**Committee of the Whole Report**

То:	Committee of the Whole	Date:	September 3, 2020
From:	Karen Hoese, Director, Sustainable Planning a	and Commur	nity Development
Subject:	Development Permit Application No. 00 Washington Avenue	0566 for 3	080, 3082 and 3090

Figure 1. Proposed Site Plan

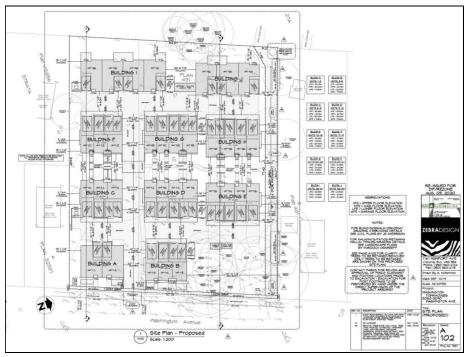
To achieve a sensitive transition and minimize impacts on the adjacent neighbours, the applicant is locating the proposed two-storey attached dwellings on the west side of the subject property, which is the highest peak of the site, and two-storey duplex adjacent to the single-family dwelling to the south. Staff have concerns with locating the other three-storey attached dwellings along the north and south side of the site that is resulting in an abrupt transition in form and massing and not respecting the site topography and the immediate neighbourhood context as shown on the site plan (Figure 1) and streetscape view (Figure 2) below. Siting the three-storey attached dwellings (Buildings B, D and G) within the middle portion of the site as proposed and reducing the heights of Buildings C, E, F and H to two-storeys is more supportable from a building transition perspective.

- revise the front elevations of Buildings D and E by replacing double car with single car garages (the proposal exceeds the parking requirements), recessing the single car garage doors and enhancing the front entryways facing the street, and selecting a different garage door design to reduce its visual prominence
- remove the parking space adjacent to Building B and the outdoor amenity space and replace with soft landscaping
- relocate the PMT stations to the interior of the site to minimize impacts on the neighbouring properties
- confirm location of garbage and recycling on site to ensure there would be no impacts on the immediate neighbours.

- 1. Revise the proposed Phasing Plan to ensure that the outdoor amenity space and Doric Connector are constructed in Phase 1 and provide more details on the potential interim conditions of each phase, to the satisfaction of the Director of Sustainable Planning and Community Development.
- 2. Refine building heights to achieve a sensitive transition to, and minimize impacts on, the adjacent neighbours.
- 3. Revise building elevations to reduce the visual prominence of garages.
- 4. Remove the visitor parking space adjacent to Building B and replace with landscaping.
- 5. Relocate the PMT to the interior of the site to reduce impacts on adjacent properties.
- 6. Confirm location of garbage and recycling on site.
